Product Change Notice P12-2019

Products affected: DRS 50010-8.6, DRS 50016-8.6, DRS 50110-8.6

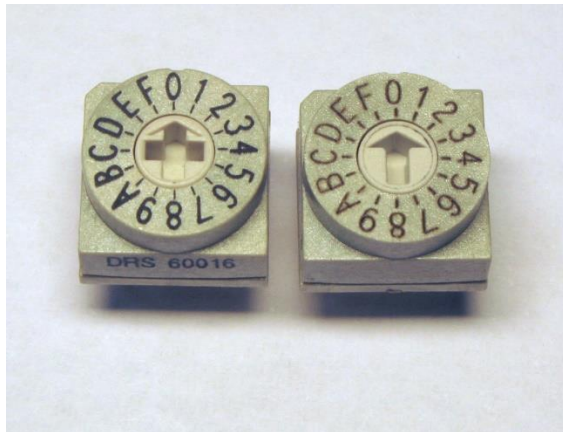
To prevent increase of delivery delay, switch position display and part number marking is changed from pad print to laser print. This change is not affecting any other features or specification of the components.

Left hand side: pad print

Right hand side: laser marking
